Re: Part 8 proposal, Reference PT8LL161 – The proposed development at Ballycummin Road, Limerick, is for the construction of a three to five storey building to include 20 no. residential units (2 no. 5-bed ground floor community units; 1 no 1-bed ground floor unit; 9 no. 2-bed units and 8 no. 2-bed Universal Design units) to be accessed by a single stair and lift core; 1 no community room (32sqm) at ground floor and all ancillary spaces. The site works consist provision of the removal of 13 no. public car spaces to Ballycurnmin Road, provision of a new vehicular entrance, 15 no. new car spaces, a new covered bin store, 30 no. bike spaces, connection to existing water main and foul sewer and the provision of an underground attenuation tank. The development includes the provision of planting and associated landscape works.

**MAYOR'S REPORT & RECOMMENDATION IN ACCORDANCE
WITH SECTION 179 3(a) OF THE PLANNING & DEVELOPMENT
ACT 2000 (AS AMENDED)**

Development at Ballycummin Road, Limerick, for the construction of a three to five storey building to include 20 residential units (2 no. 5-bed ground floor community units; 1 no. 1-bed ground floor unit; 9 no. 2-bed units and 8 no. 2-bed Un

Plate 2 ***Modification 1 – Reduction in Height of Building – View from Ballycummin Road***

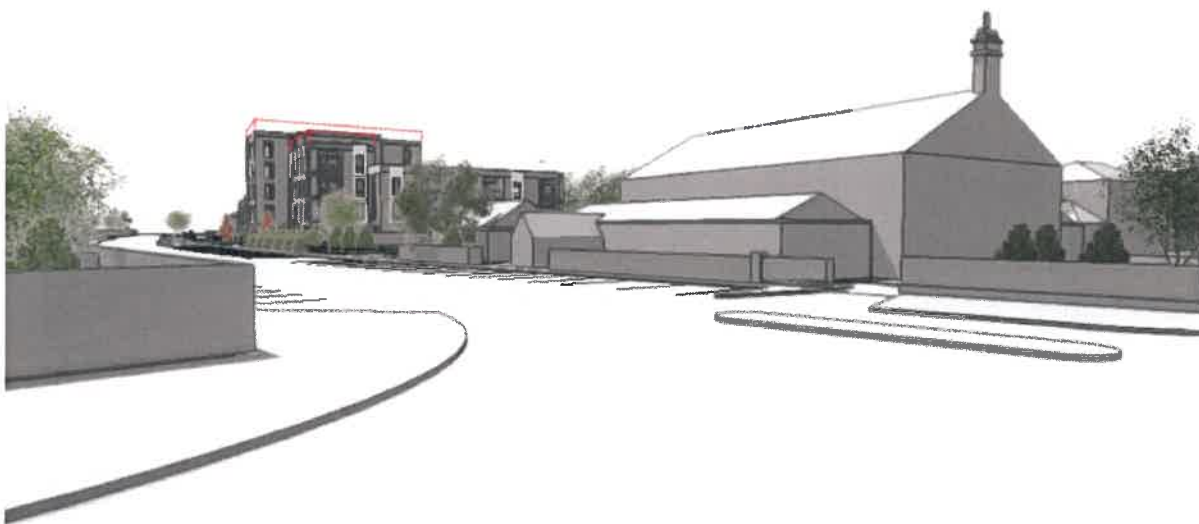
Modifications to the development as submitted consist of a 1.6 m reduction in height to the 4 and 5 storey elements of the building. These reductions were achieved by

reducing the floor-to-floor height of each floor and reducing the parapet height. The location of the PV panels has been replaced to the roof of the 3 storey element with access to be provided by external ladder.
